MONTGOMERY COUNTY HISTORIC PRESERVATION COMMISSION
STAFF REPORT

Address:	10201 Menlo Ave.	Meeting Date:	2/7/18
Resource:	Contributing Resource Capitol View Historic District	Report Date:	1/31/18
Review:	HAWP	Public Notice:	1/24/18
Case Number:	37/07-17G (continued)	Tax Credit:	None
Applicant:	Minter Farnsworth	Staff:	Dan Bruechert
Proposal:	New Construction

Staff recommends that the HPC **approve with two (2) conditions** the HAWP application.

Figure 3: Streetscape study showing the proposed construction (right) and existing buildings (a larger version of this drawing is included in the application materials).

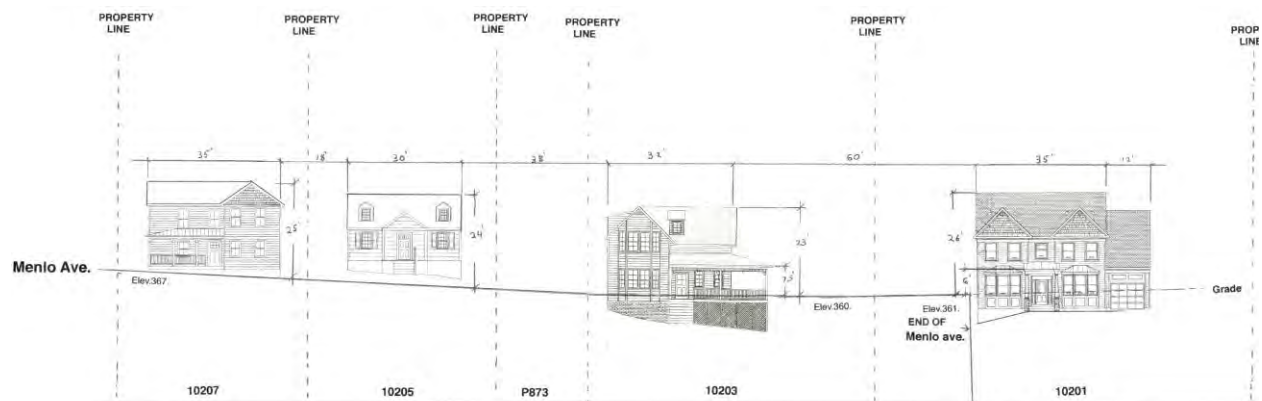
At the October 25, 2017 hearing, questions were raised about the siting of the house and whether it could be better shielded from the public right-of-way or more fully integrated into the streetscape. In response, the applicant provided a survey completed by Witmer & Associates detailing the areas of the lot that are restricted by conservation and utility easements. The survey identifies a 5,160 ft² (five thousand sixty feet square) buildable envelope. The entirety of this envelope is to the south of Loma St., and is significantly removed from Menlo Ave. Staff feels that this location will neither add to nor detract from the historic character of the streetscape along Menlo. Portions of the house will still be visible from the public right-of-way. Staff feels, however, any construction on this lot will not read as part of the historic gridded street pattern that makes up much of the Capital View District (see below). The streetscape study does show that the proposed house will be slightly taller than the surrounding houses (twenty-six feet compared to twenty-three feet) and slightly wider (thirty-five feet compared to thirty-two feet), which will not overwhelm its neighbor. Lastly, as the lot slopes away from the street, the house will be constructed approximately 6' (six feet) below street grade, which will minimize the impact the house has on the surrounding district.

Staff has also evaluated the impact this house will have on its neighbors on Barker St. Due to the topography of the surrounding area, the proposed house at 10201 Menlo will sit higher than the houses at 2801 and 2905 Barker St. Staff recognizes that a developed lot with a house will have more of an impact than an undeveloped lot to neighbors and the surrounding district. But as to these two specific parcels, the proposed construction will be approximately 140' (one hundred and forty feet) from the rear wall of 2905 Barker St. and approximately 160' (one hundred and sixty feet) from the rear wall of 2801 Barker St. Additionally, the proposed house is situated to the north northwest of these two properties and will not significantly impact the sunlight these houses receive. Staff finds that the current proposal would not seriously impair the historic or architectural character of the surrounding historic resources or historic district (per 24A-8(d)) and Staff supports its approval.

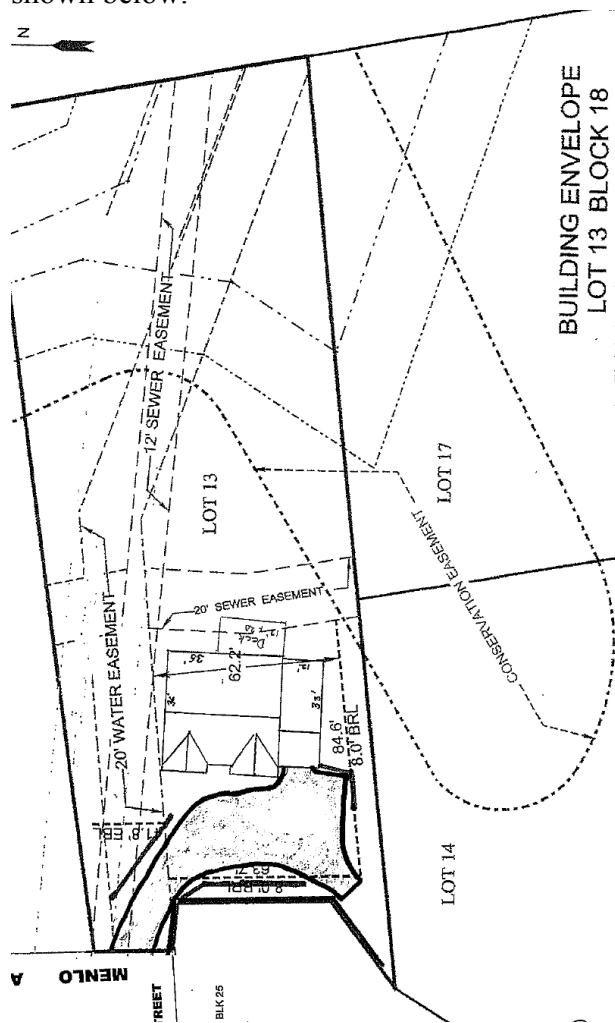
Staff believes that the simple rectangular house form with a side gable roof will fit in with the surrounding district and will not detract from the historic streetscape.

Some members of the HPC and the public expressed concerns that the house was out-of-scale with the surrounding district. The applicant provided a table (see Circle __) showing the proposed house and the neighboring properties. This information shows that the house size is generally consistent with the surrounding properties. The total lot coverage of the subject property, if approved, will be higher than some surrounding properties. This is largely due to the large driveway and proposed parking area. In evaluating this information, Staff feels that the size of the house and the treatment of the landscape is not disproportional to the neighboring properties and Staff supports approval of the house.

HPC Streetscape plan

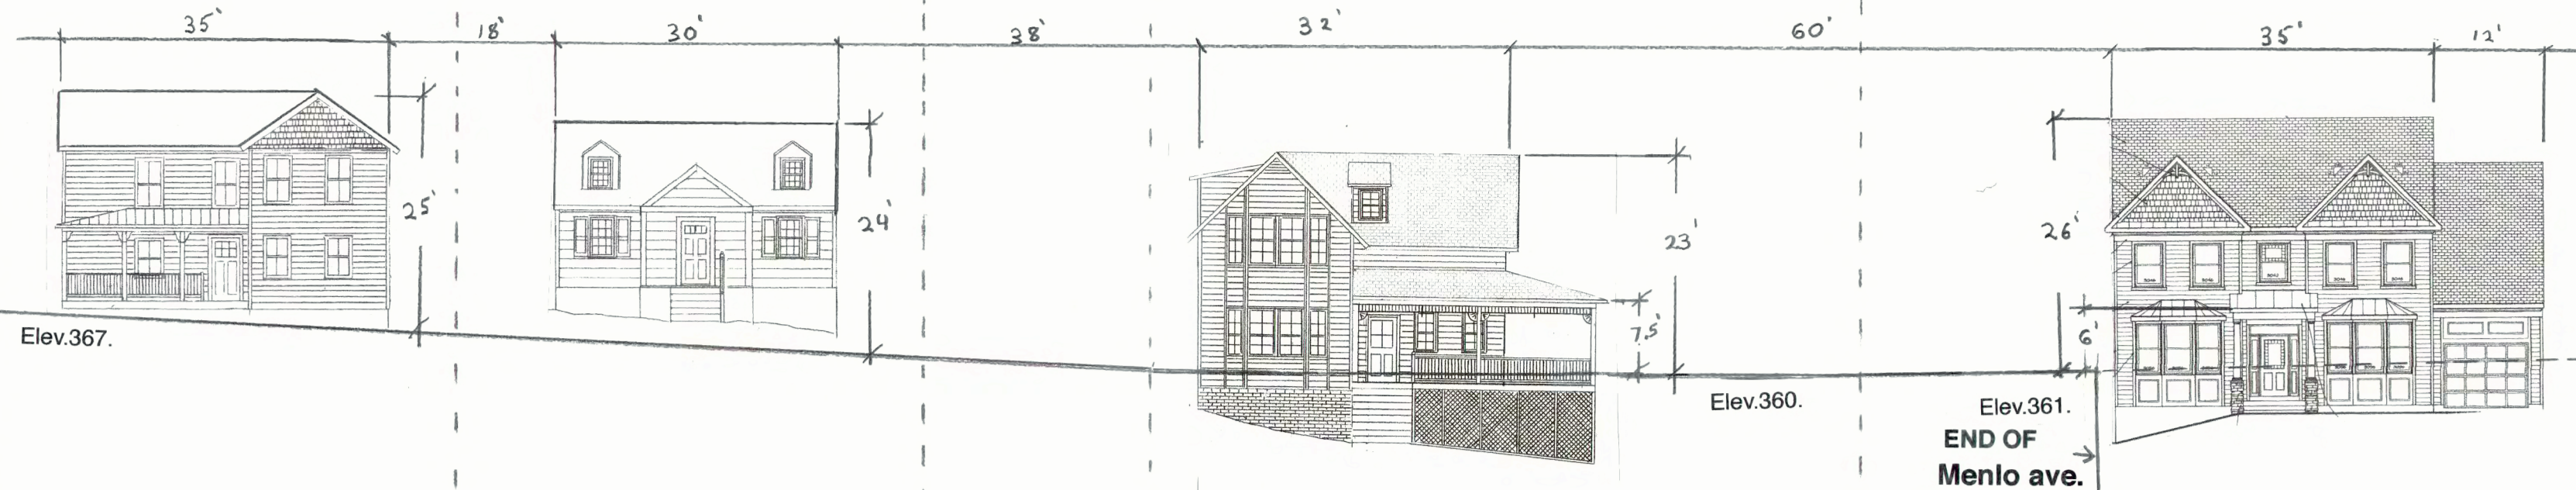
Massing and scale is something many witnesses did bring up, and I think, you know, that is something that I am concerned about with this resource. What we don't have before us tonight is the ability to compare the house footprint with its neighbors. We have a drawing that shows us the house on the site, and we have drawings that show the neighborhood with footprints for those houses. And I think we need to see a composite drawing that allows us to judge whether we think the footprint is

So, just to conclude. I think for me to provide a finding on this application, I do need to see a proper tree removal and protection plan, a footprint comparison within the neighborhood, and a street elevation comparison of the front facade with the adjoining properties. Whoever wants to go next, please do.

Landscape Plan

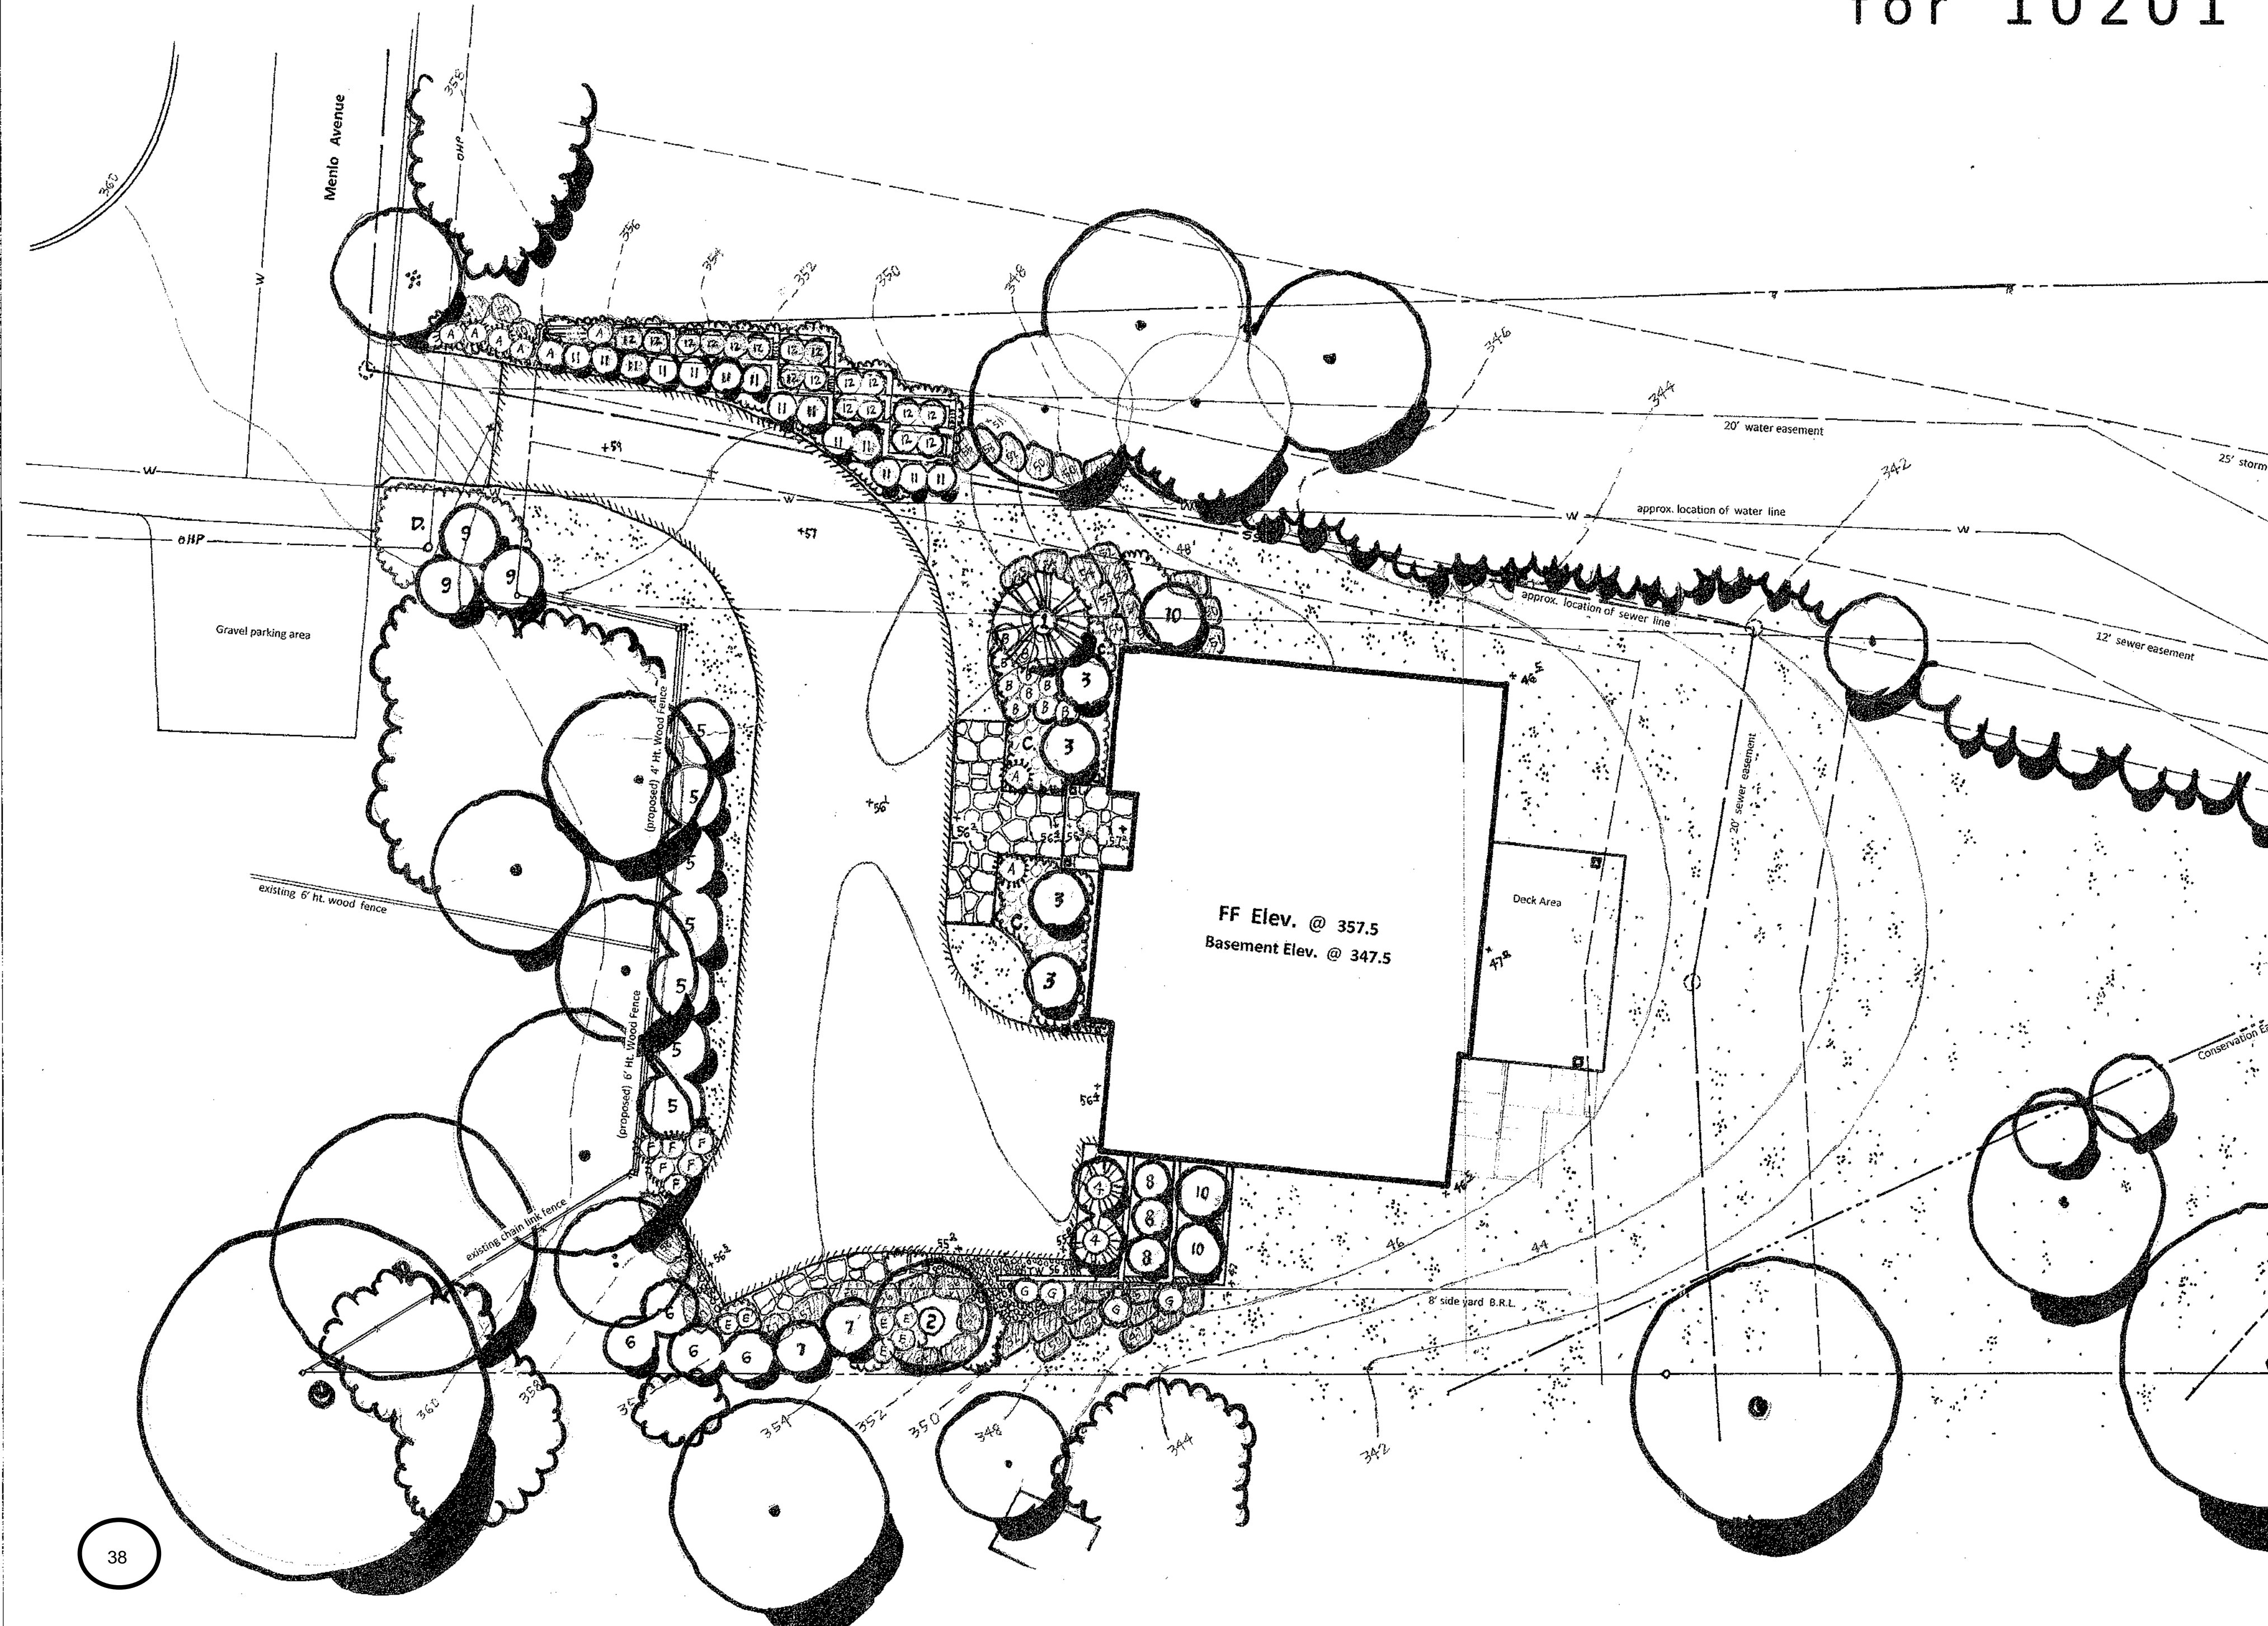
I think the issues that I'm concerned about, both hearing from the applicant and hearing from the witnesses, is tree removal. I think a tree removal plan that both shows existing trees that are remaining and trees that are going to be protected, I think needs to be very clearly presented. I don't see that in the Staff Report we've seen tonight. I see sort of hand marked up notes about where trees are located, and we've heard a lot of testimony conflicting with what is on that drawing. So I think we need to see a final tree removal plan. That's my recommendation for approval of this historic area work permit.

But I am going to concur with our Chairman and the other two Commissioners. I feel that there's not quite enough information here for me to approve something like this tonight. I'm definitely concerned about the tree plan, first of all. A better survey of what trees are there, and what is actually going to be removed, and what's going to be left. And two, a plan to protect the trees, the remaining trees that are not going to be removed.

1. Details for the proposed windows must be submitted with permit drawing for review and approval with final approval authority delegated to Staff.
2. Placement and species of new trees must be submitted with permit drawings for review and approval with final authority delegated to Staff.
